Comment on acp-2022-412

Anonymous Referee #2

Referee comment on "Validation of the TROPOMI/S5P Aerosol Layer Height using EARLINET lidars" by Konstantinos Michailidis et al., Atmos. Chem. Phys. Discuss., <https://doi.org/10.5194/acp-2022-412-RC1>, 2022

Figure RC1-1. Sensitivity test to define the effect of overlap altitude on ALH_{bsc} calculation under different scenarios (Thessaloniki 15 Oct 2022)- Dashed lines correspond to the different overlap assumption.

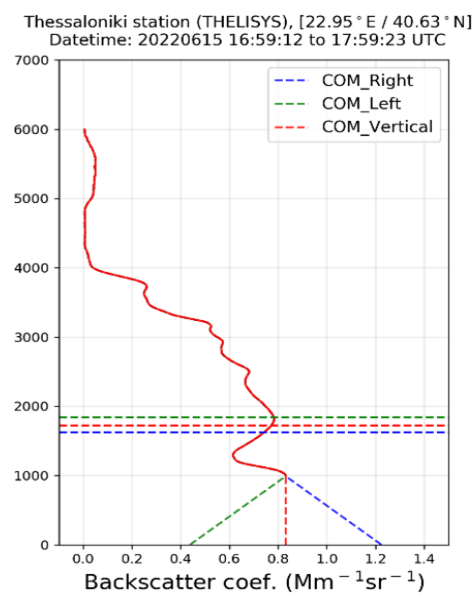
In this study, the geometrical features from ground-based lidars were compared against the ALH product from TROPOMI. I was wondering since most of the ground-based lidars used in this study have a lower detection limit at around 700-800m, if not higher, how was this taken into consideration when calculating the ALH? How did the authors tackle the overlap issue in the ground-based lidar observations and what is the error from ground-based lidar overlap limitation to the calculated ALH? For example, in the smoke episode the lidar signal is cut below 1km (Figure 11 and Figure 14). I assume that the bias is not big (equation 1) but given that the attempt is to validate a satellite product this effect should be discussed.

The reviewer raises a crucial issue regarding how the overlap altitude can affect the lidar-based ALH estimates. In the initial submission we did not consider the effect of the overlap in the estimation of the ALH from a lidar measurement.

To overcome this issue, in the revised version, we rely on certain assumptions. To calculate the ALH_{bsc} from the lidar backscatter profiles using equation 1 (Sect. 2.3), for the height range between the surface and the full overlap height we assumed a constant backscatter coefficient (height-independent) equal to the one measured at the full overlap height. This is general acceptable since the Planetary Boundary Layer (PBL) is characterized as well-mixed aerosol conditions (Siomos et al., 2018). This assumption obviously affects the calculation of the lidar aerosol height (ALH_{bsc}) compared to the ones shown in the initial submission since it also considers the contribution of the aerosol load in the lowermost part of the atmosphere. The ALH_{bsc} estimates, when considering this part of the profile, are therefore smaller and the bias with TROPOMI is reduced.

In order to quantify the uncertainty of the ALH_{bsc} estimates due to assumption we made for tackling the incomplete overlap issue we performed a number of sensitivity tests. An example case over Thessaloniki on 15 June 2022 is presented in the **Figure RC1-1** which demonstrate the effect of the overlap altitude on the lidar ALH calculation for different scenarios. Dashed colored lines correspond to the different indicative assumptions for the backscatter coefficient profile below the overlap height. The horizontal-colored lines indicate the corresponding lidar

weighted height. The scenario with a negative slope of backscatter in lower part is indicated in green, the case for vertical extension (zero signal slope) in red, and the third with a positive slope in blue. After applying the above sensitivity tests to all lidar measurements (N=63) used in the study, we can conclude that the effect of the different assumptions shown on the calculation of ALH_{bsc} is of the order of 100 - 400m, depending on the technical characteristics of each lidar system.
